# Cottam Solar Project

### Figure 8.16.3: Landscape and Ecology Mitigation and Enhancement Plan – Cottam 1 North (Sheet 3) Revision A

Document reference: EX1/C6.4.8.16.3\_A

## Schedule of Changes

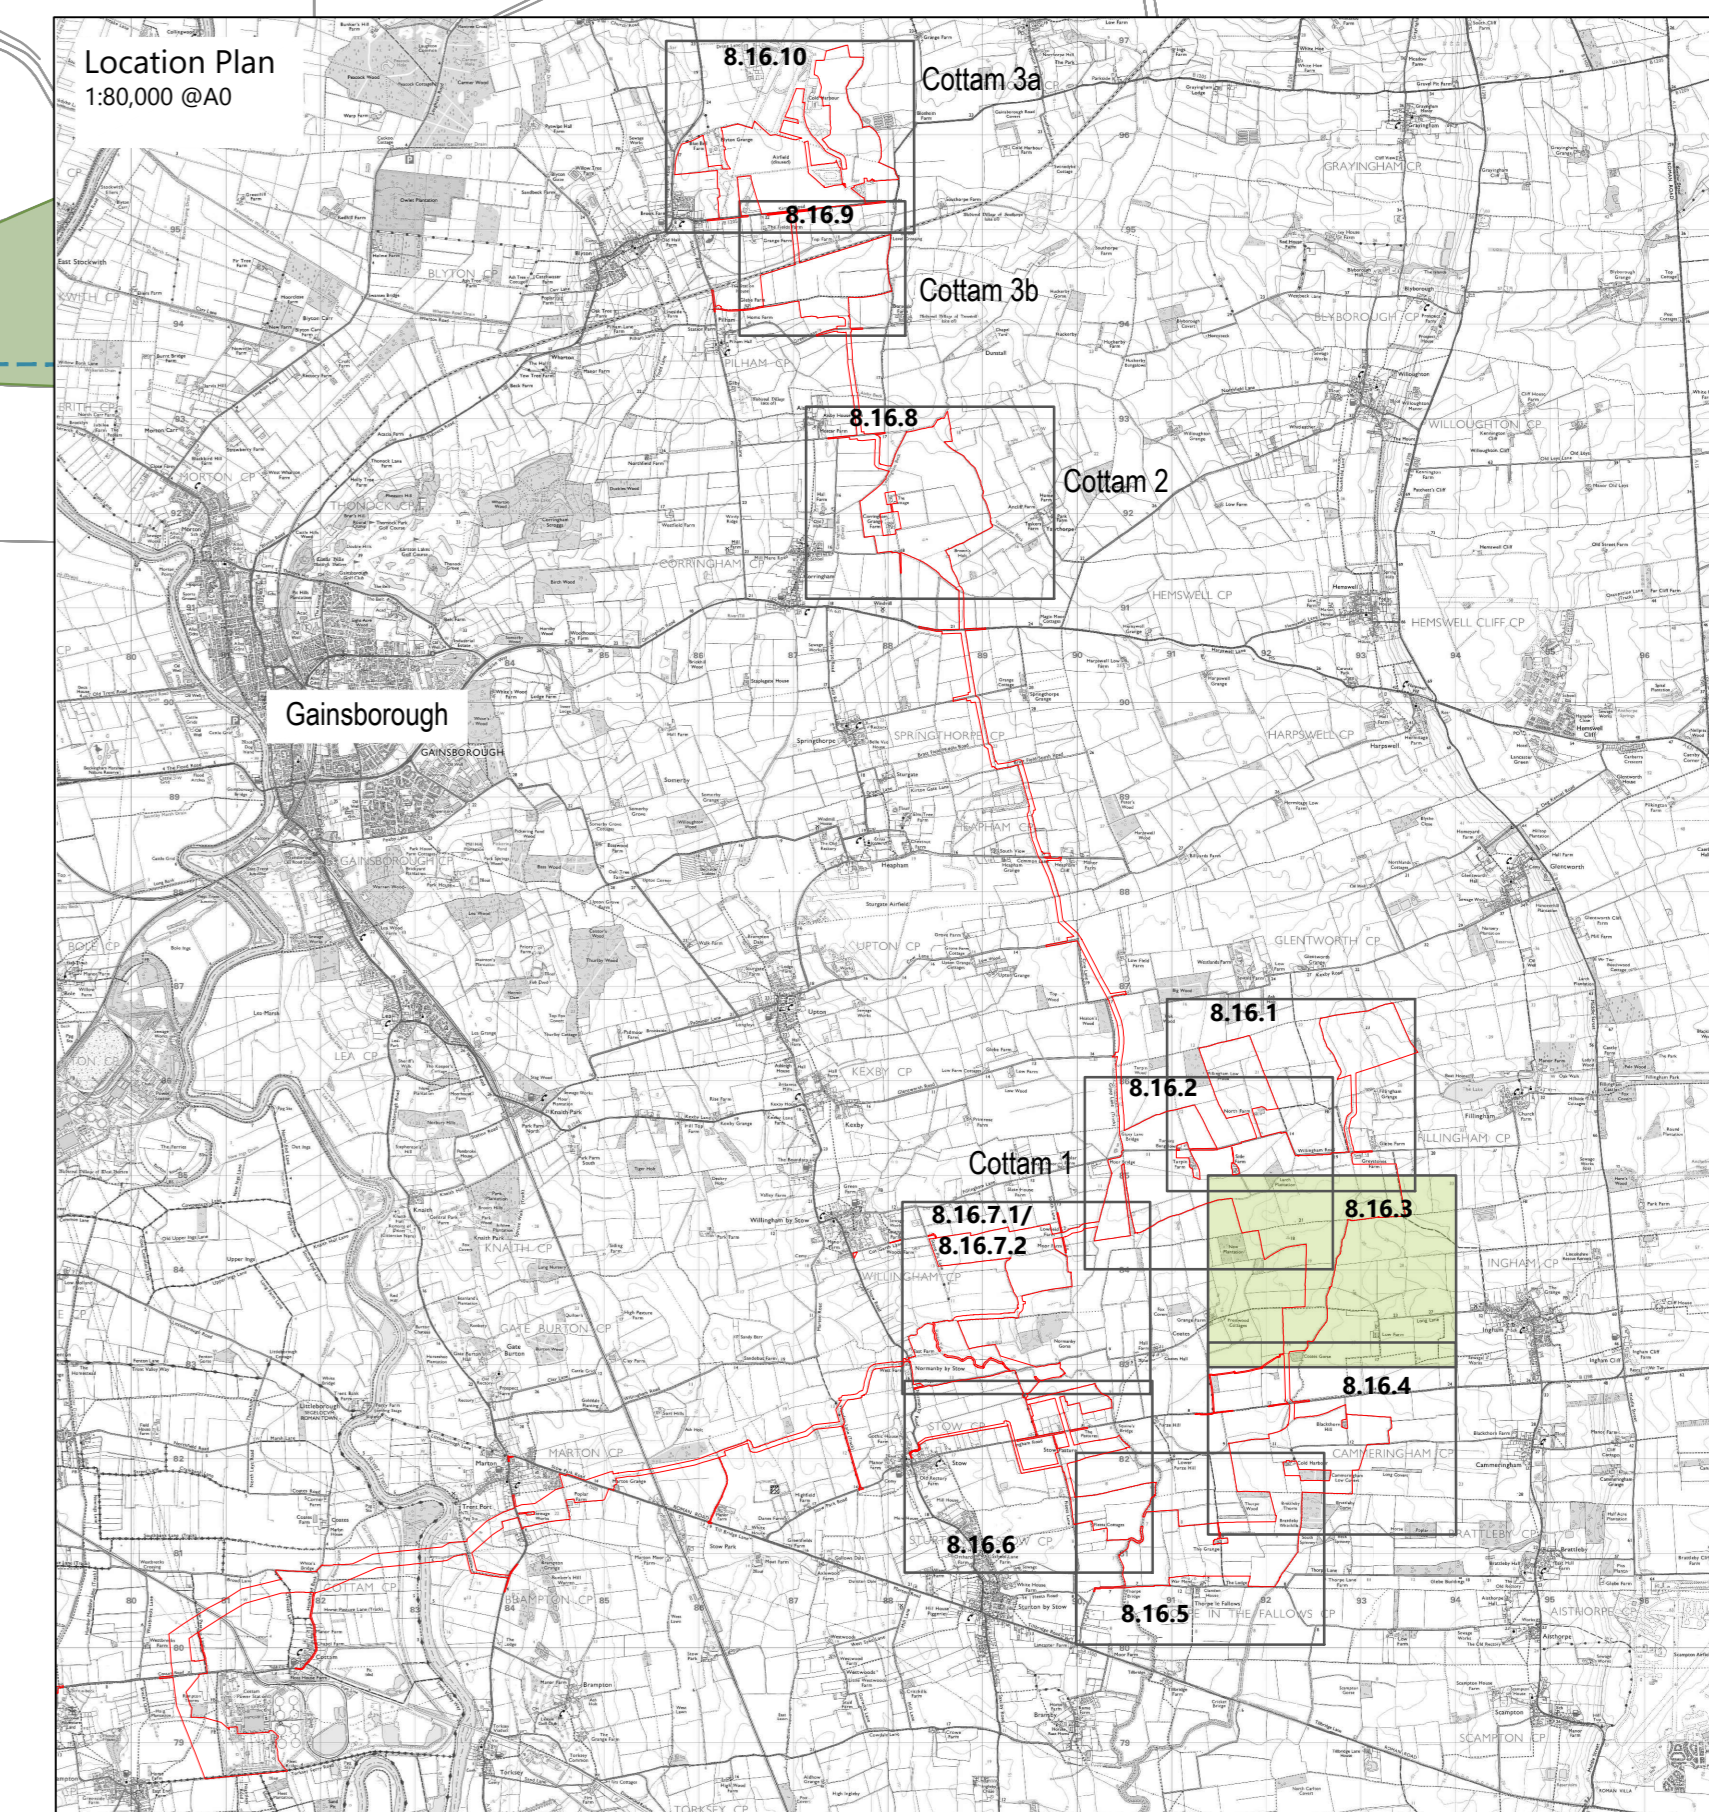
Figure Reference	Page	Description of Changes	Reason for Revision
Figure 8.16.3	3	Change to spelling of 'enhancement'. Offset calculations from drains. Additional Hedgerows to be removed.	For clarity and consistency. To correct a typo.
